Project	<b>IEEE 802.16 Broadband Wireless Access Working Group</b> < <a href="http://ieee802.org/16">http://ieee802.org/16</a> >	
Title	<b>Improved Data and Pilot Allocation for Cellular OFDMA Systems with Multiple Antennas</b>	
Date Submitted	<b>2004-07-08</b>	
Source(s)	<p>Wonil Roh, JeongTae Oh, Chan-Byoung Chae, Kyunbyoung Ko, Hongsil Jeong, Sung-Ryul Yun, Seungjoo Maeng, Panyuh Joo, Jaeho Jeon, Jaeyeol Kim, Soonyoung Yoon</p> <p><b>Samsung Electronics Co., Ltd.</b></p> <p>Wen Tong, Peiying Zhu, Jianglei Ma, Ming Jia</p> <p><b>Nortel Networks</b></p> <p>Erik Lindskog, Brett Schein, Kamlesh Rath, K. Giridhar, Aditya Agrawal, David Garrett, B. Sundar Rajan, A. Paulraj</p> <p><b>Beceem Communications, Inc.</b></p>	<p><a href="mailto:wonil.roh@samsung.com">wonil.roh@samsung.com</a></p> <p>Voice: +82-31-279-3868</p> <p><a href="mailto:wentong@nortelnetworks.com">wentong@nortelnetworks.com</a></p> <p>Voice: +1-613-763-1315</p> <p><a href="mailto:elindskog@beceem.com">elindskog@beceem.com</a></p> <p>Voice: +1-408-387-5014</p>

Re:	Contribution supporting TGe WG ballot #14b	
Abstract	Improved Data and Pilot Allocation for Cellular OFDMA Systems with Multiple Antennas	
Purpose	Adoption

[Figure bbb - Pilot allocation for 2-antenna BS for the optional FUSC and the optional AMC zones](#)

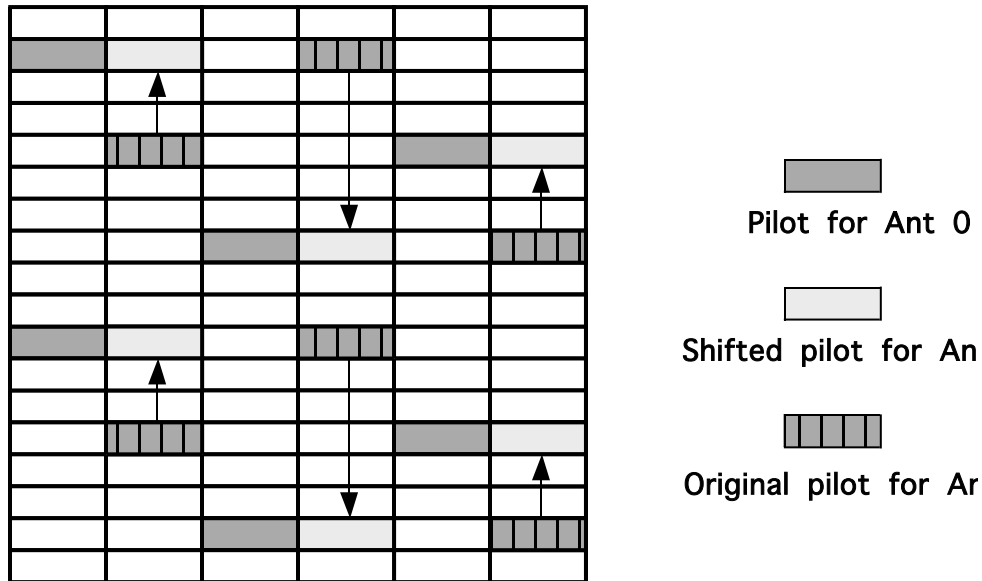
[For 2-antenna BS, all pilots in the even symbols shall be allocated for antenna 0 whereas all pilots in the odd symbols shall be allocated for antenna 1. The positions of pilots in the odd symbols are further switched with those of data subcarriers whose locations coincide with pilots in the previous symbol. This is shown in Figure bbb.](#)

Figure ccc - Pilot allocation for 4-antenna BS for the optional FUSC and the optional AMC zones

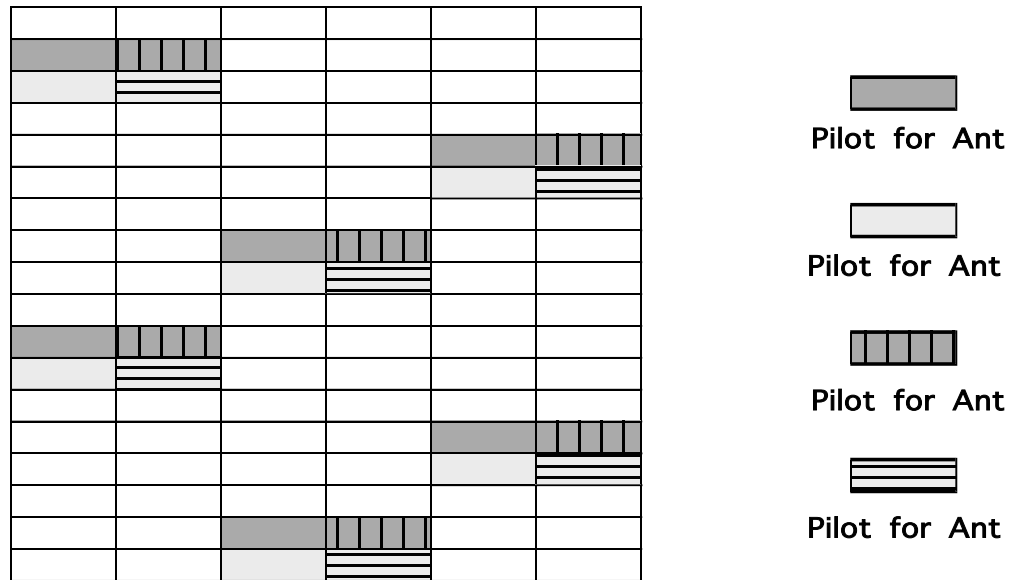
[For 4-antenna BS with more than 2 antennas, pilot pattern shall first be changed as in the 2-antenna BS case, and then the neighboring two subcarriers shall be further punctured-allocated to pilots for other antennas, 2 and 3 as is shown in Figure ccc shows the pilot allocation scheme for 4-antenna BS.](#)

Figure ddd - Uplink pilot allocation for 2-antenna SS for the optional PUSC zones

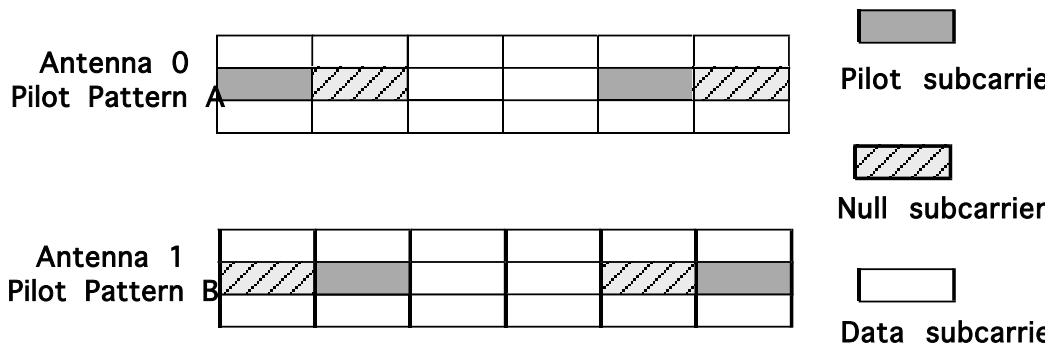
For 2-antenna SS and the optional PUSC, pilots for each antenna shall be allocated as shown in Figure ddd.

Figure eee - Uplink pilot allocation for 2-antenna SS for the optional AMC zones

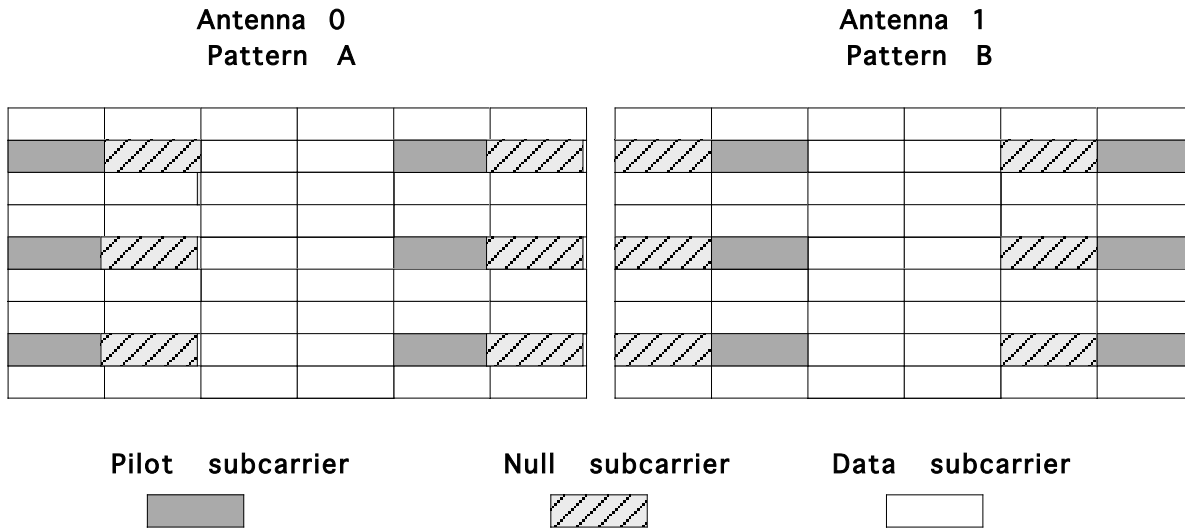
~~For 2-antenna BS and the optional AMC, all pilots in the 1<sup>st</sup>, 2<sup>nd</sup>, 5<sup>th</sup> and 6<sup>th</sup> symbols shall be allocated for antenna 0, 1. This is shown in Figure eee.~~

For 2-antenna SS and the optional AMC, all pilots in the 1<sup>st</sup>, 5<sup>th</sup> symbols shall be allocated for antenna 0, while pilots in the 2<sup>nd</sup> and 6<sup>th</sup> symbols shall be allocated for antenna 1. This is shown in Figure eee.
